**ADDENDUM
NO. 02**

July 14, 2022

**Zionsville Community High School Soccer Stadium and Parking Expansion
4400 S 875 E
Zionsville, IN 46077**

ADDENDUM NO. 2

G4.2

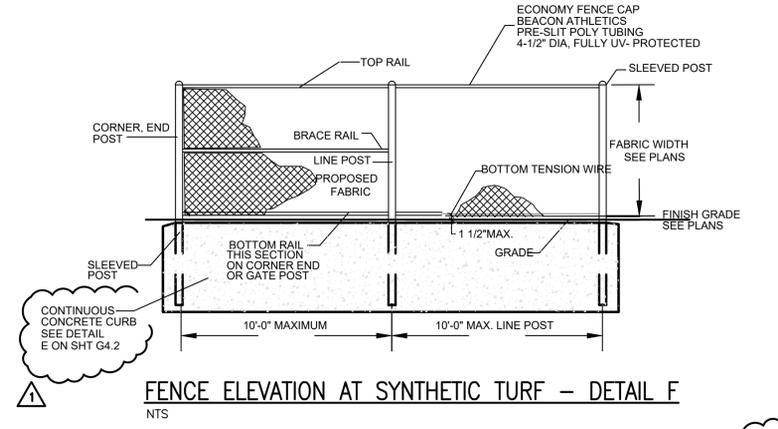
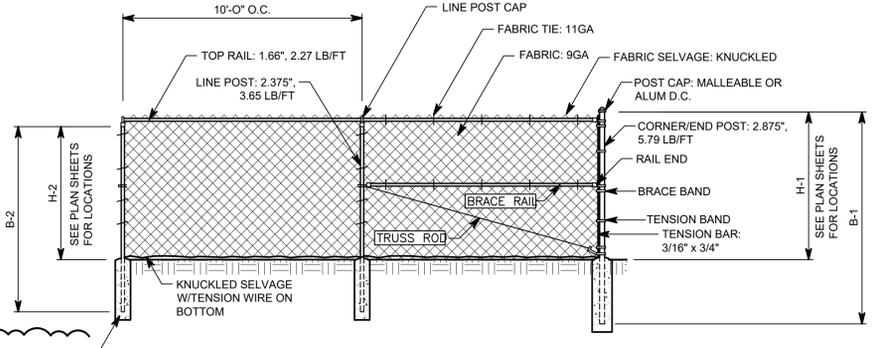
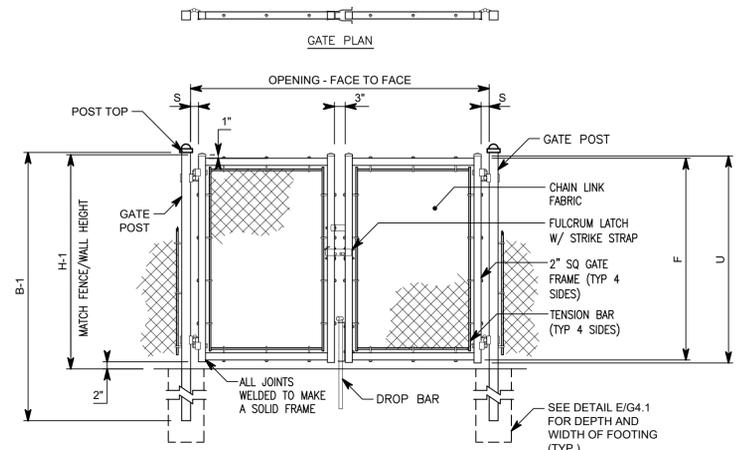
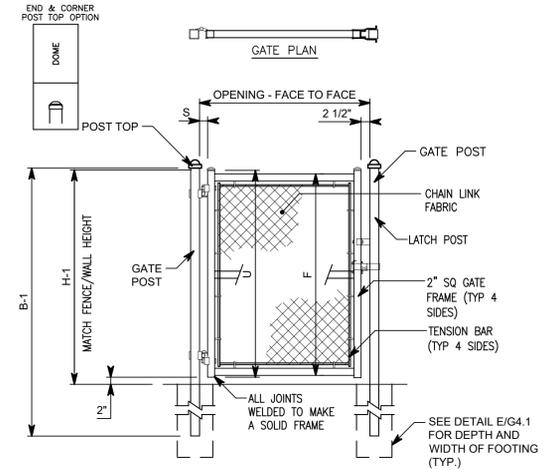
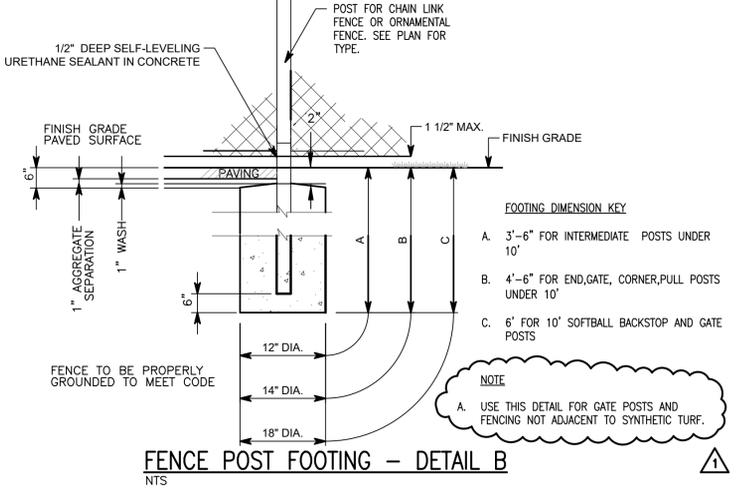
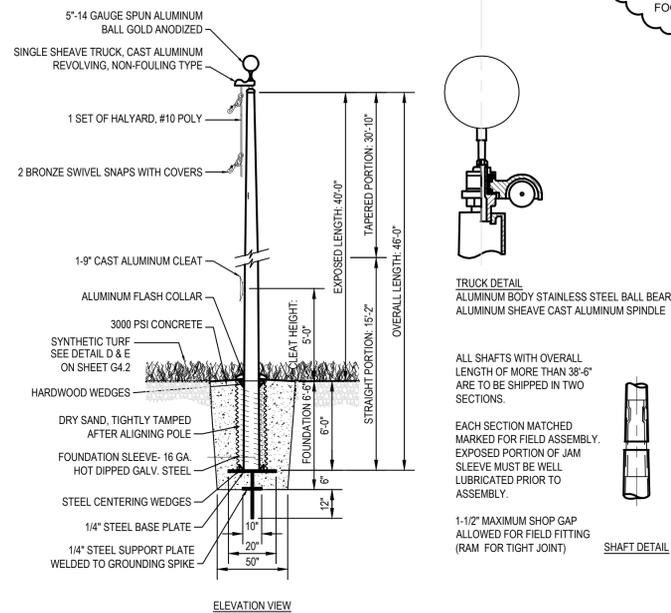
A. Replace 3.1, H., as follows:

“H. Line Posts: Space line posts uniformly at 10'-0” o.c.”
